Proposal #15: 1140-00-77, WISC 2026056
New London - Clintonville
Givens Road to Church Road
USH 45
Outagamie & Waupaca Counties

6220-04-76, WISC 2026057
New London – Black Creek
W Jeanne Street to CTH S
STH 54
Waupaca & Outagamie Counties

Letting of November 11, 2025

This is Addendum No. 01, which provides for the following:

Addendum No. 01
ID 1140-00-77
Revised Sheet 27
November 4, 2025

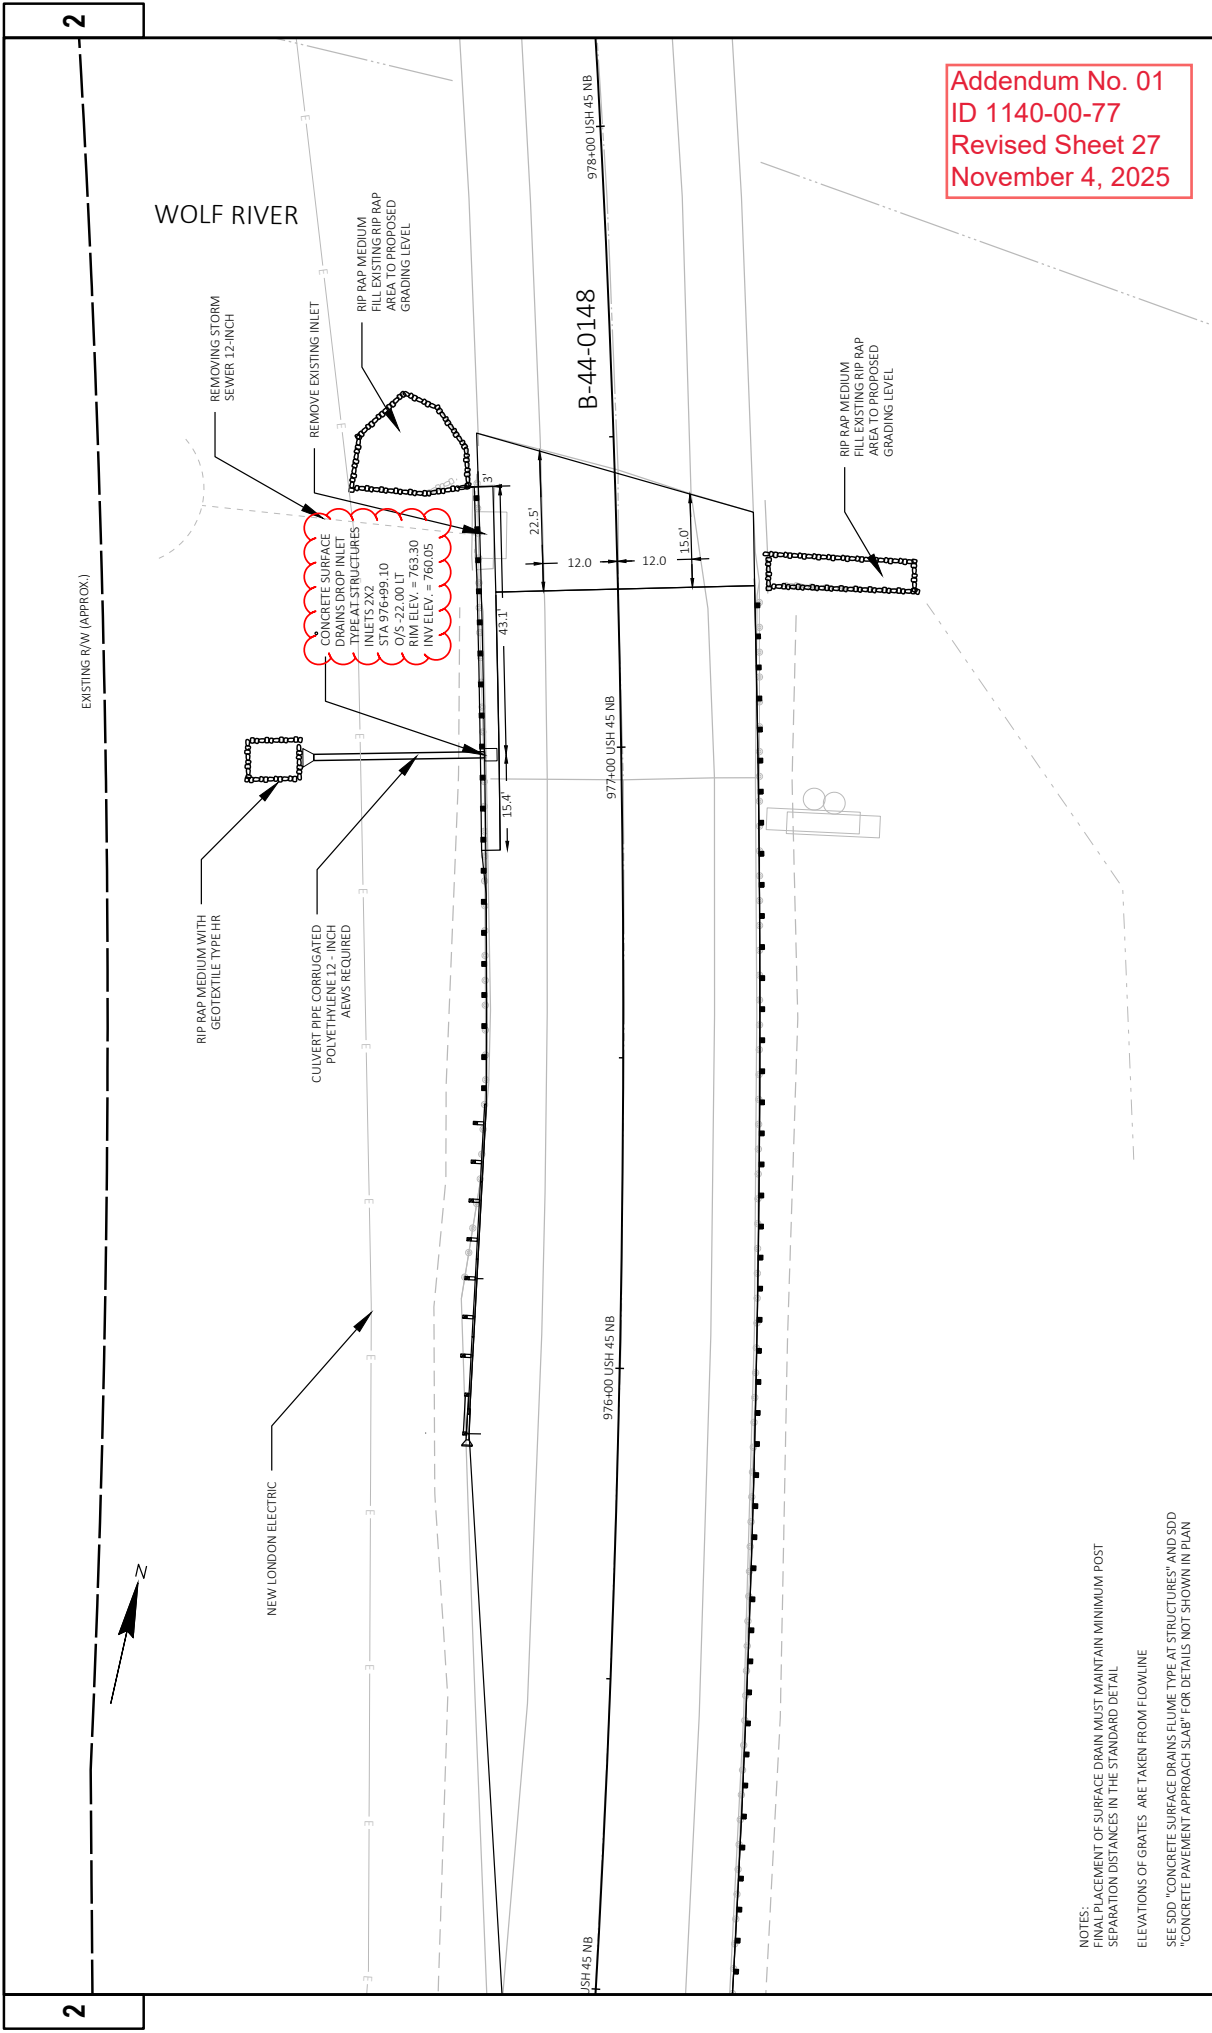
Revised Plan Sheets	
Plan Sheet	Plan Sheet Title (brief description of changes to sheet)
27,28,29,30,31	1140-00-77 Question #2 (5 pages) – Add rim and invert elevations to surface drain inlets.
70,71	1140-00-77 Question #2 (2 pages) – Add rim elevations to roundabout inlets.
156,157,158	1140-00-77 Question #2 (3 pages) – Add rim and invert elevations to inlets. Updated existing profile elevations.
131	1140-00-77 Question #3 and #4 (1 page) – Update Earthwork Tables in MQs.
477- 482	6220-04-76 Question #6 (6 pages) 13-18 (477-482) – Update HMA Mix Type label in Typical Sections.

10-77	HWY: USH 45	COUNTY: OUTAGAMIE & WAUPACA	MISCELLANEOUS QUANTITIES	SHEET
THYONE DRIVE - DAAR CORPORATE DOCUMENTS - NC DESIGN1140-07 USH 45 SOUTH, WAUPACA COUNTY CD1140007(SHEETS)PLAN03001 IMG.DWG				1" = 1'
PLOT DATE : 10/29/2025 5:43 PM		PLOT BY : FREDERICK KOTH		PLOT SCALE :

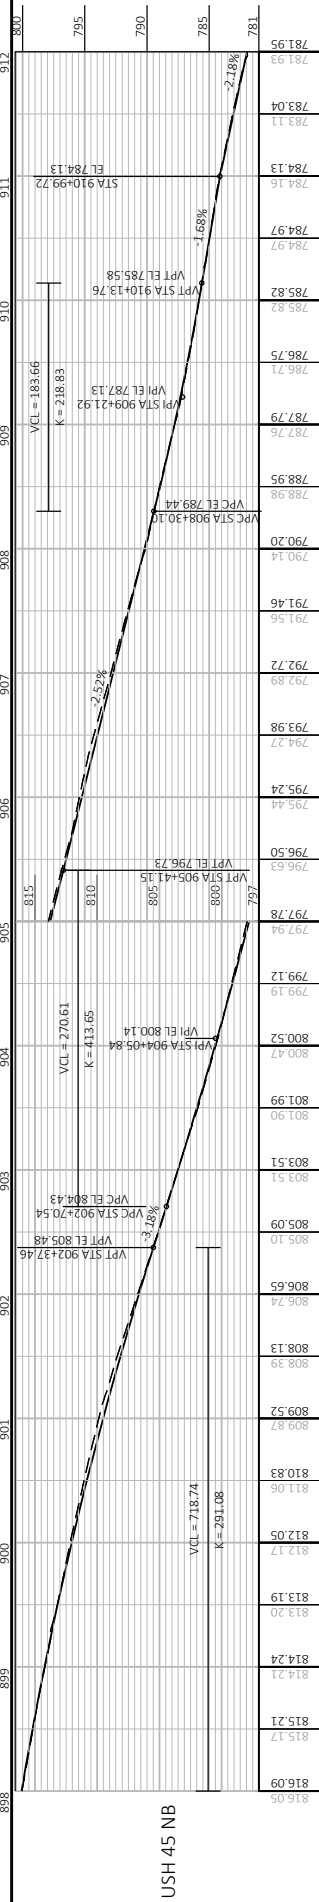
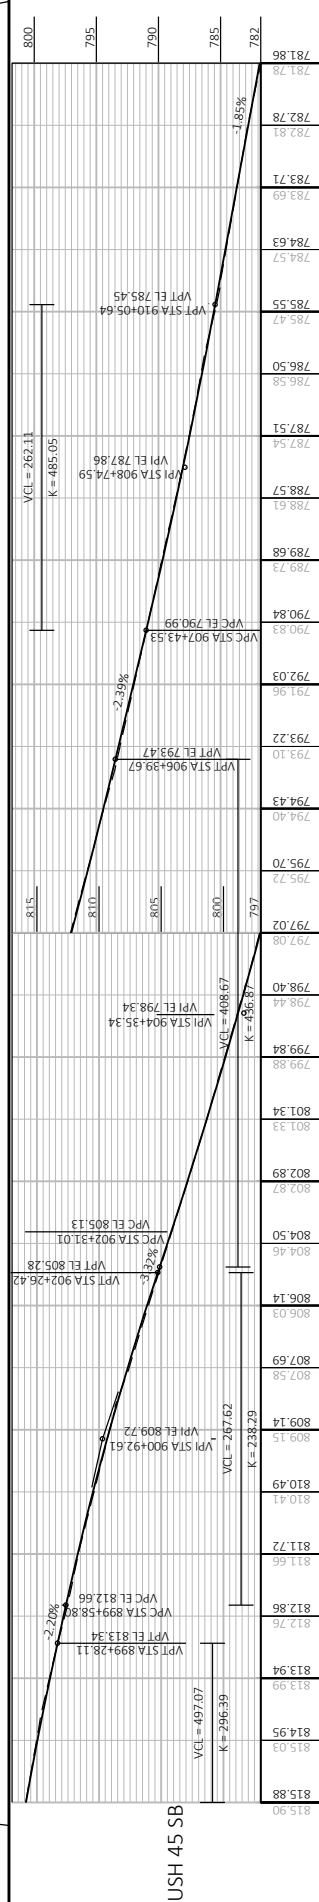
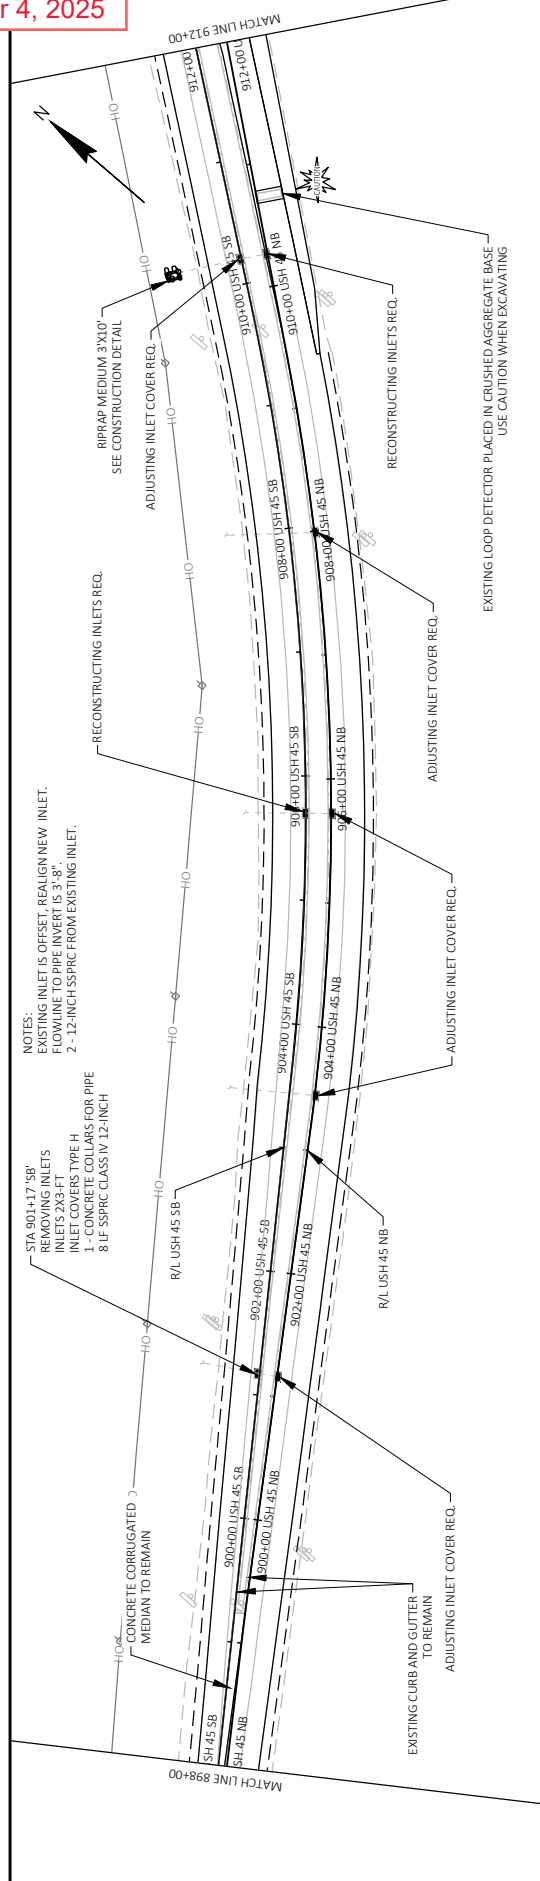
Revised Bid Item Quantities – ID 1140-00-77					
Bid Item	Item Description	Unit	Proposal Total Prior to Addendum	Proposal Quantity Change (-)	Proposal Total After Addendum
205.0100	Excavation Common	CY	52,929	-40	52,889
